SF Sweaters Ltd. Building – 2

17th May 2017

Observations

Retrofit Ground to 1st Floor Column Layout Plan

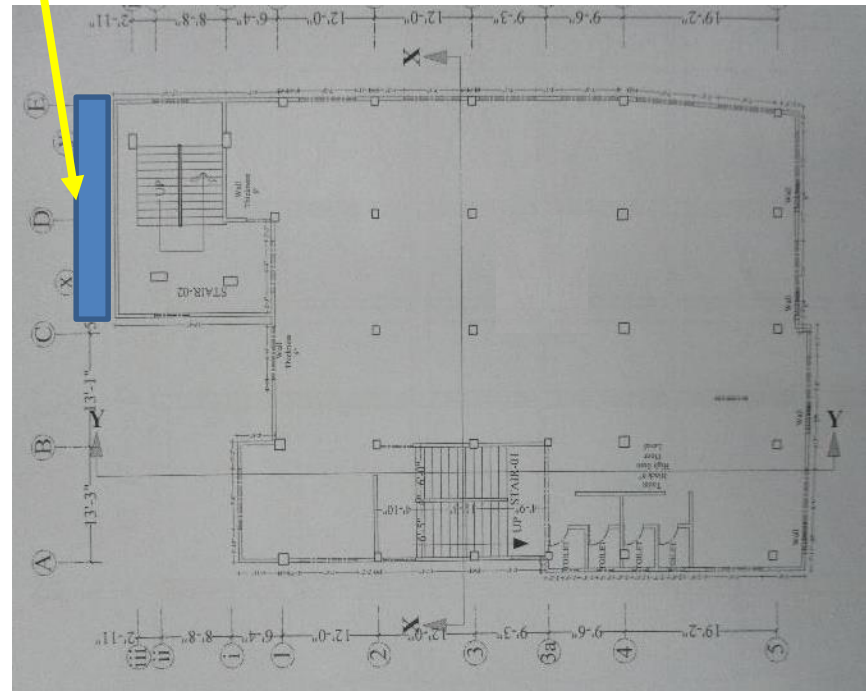
Undocumented cantilever portion
observed on roof.

Building Engineer required to update As-Built drawings incorporating the extended portion of roof.

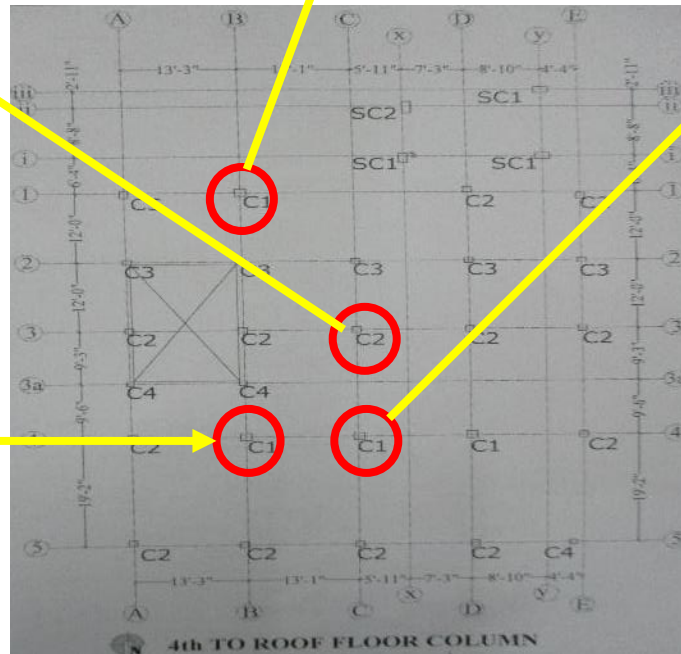
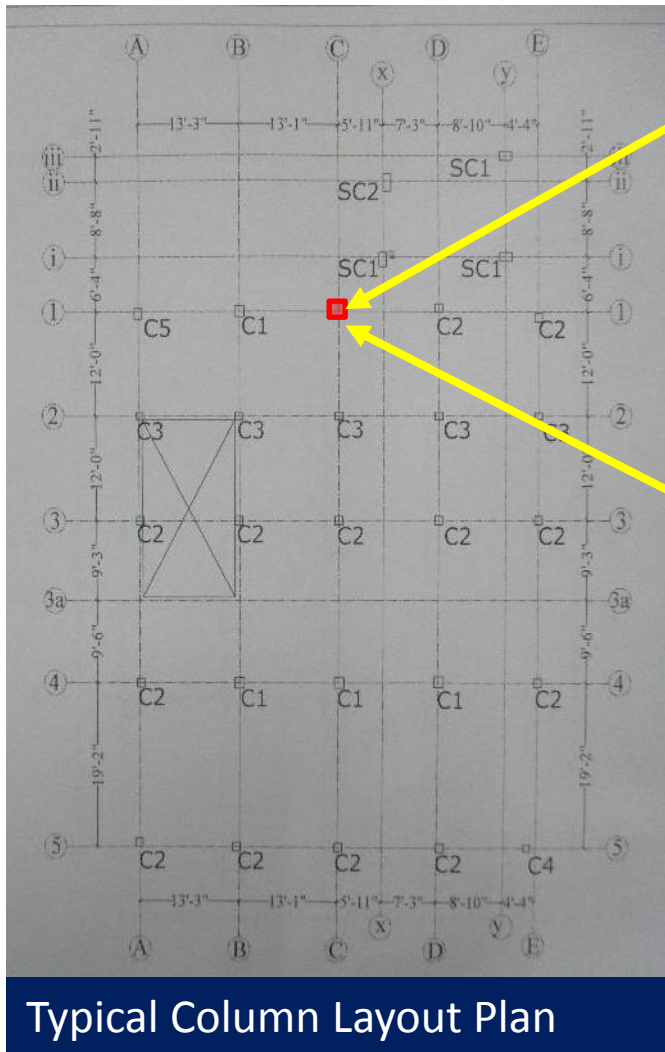
C2: 7- 20mm+3-16mm on roof

C1: 3- 16mm+9- 20mm on roof

C1: 2- 16mm+5-20mm+2- 16mm on roof

C1: 2- 16mm+5-20mm+2- 16mm on roof

Building Engineer required to update As-Built drawings incorporate the verified number of reinforcement in columns.

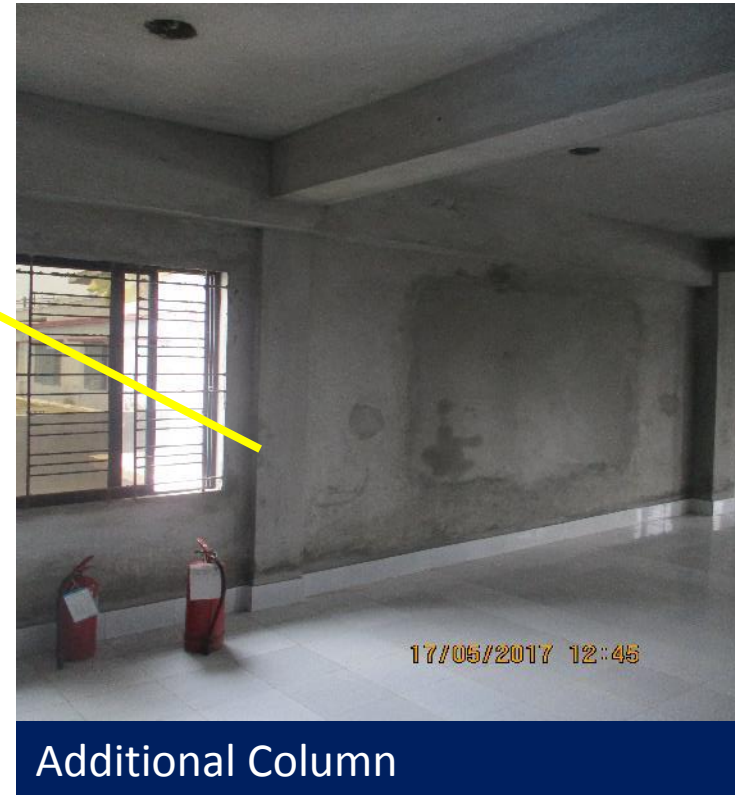
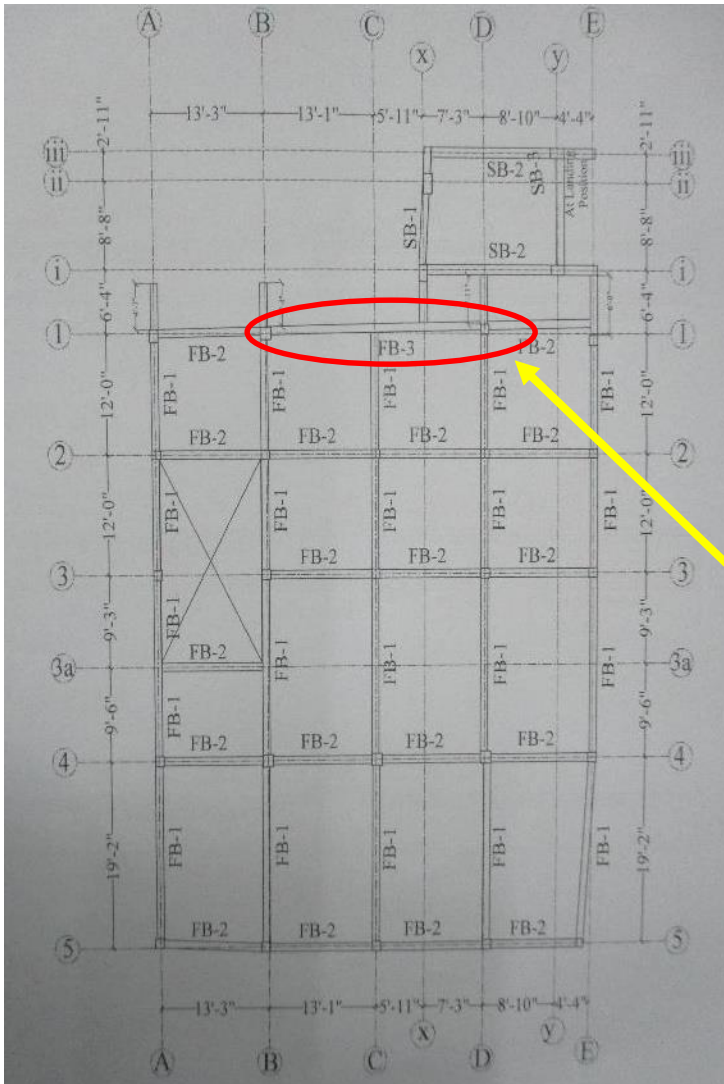
Additional Column was observed from 2nd floor to roof.

Typical Beam Layout Plan

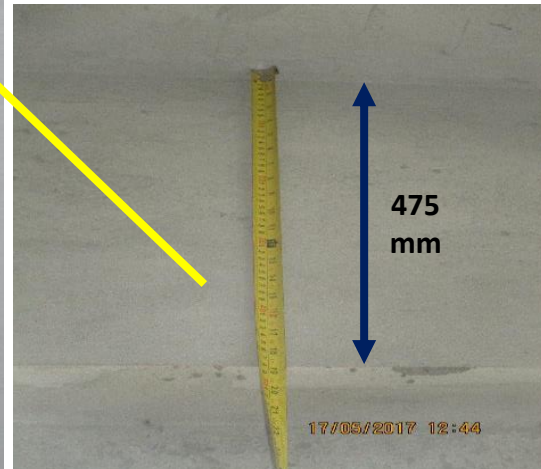
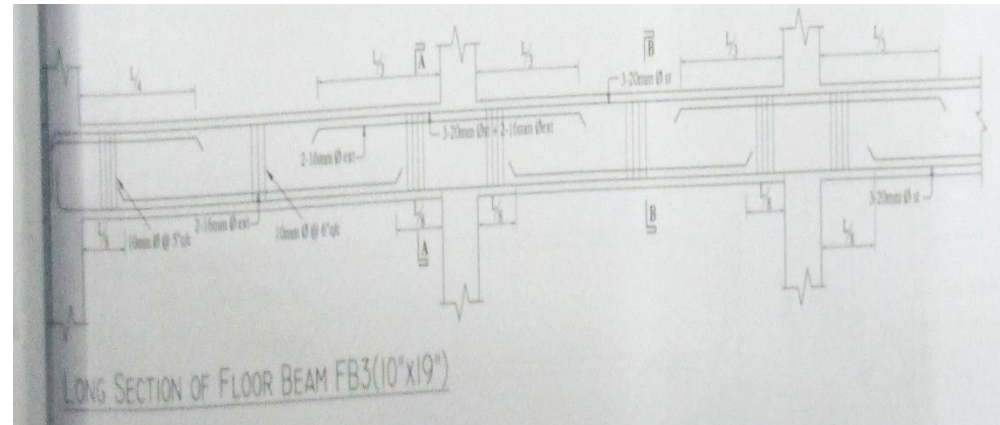
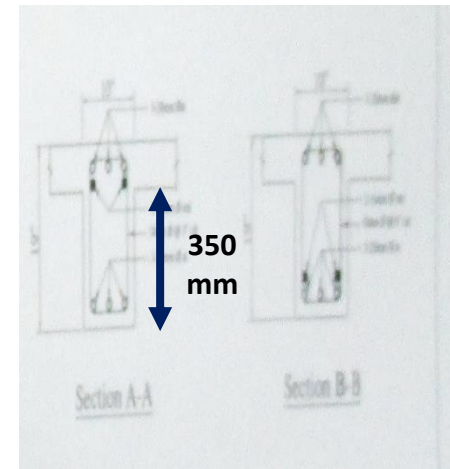
Down stand of beam
observed 475mm instead
of 350mm

Cross section of FB-
3 Beam
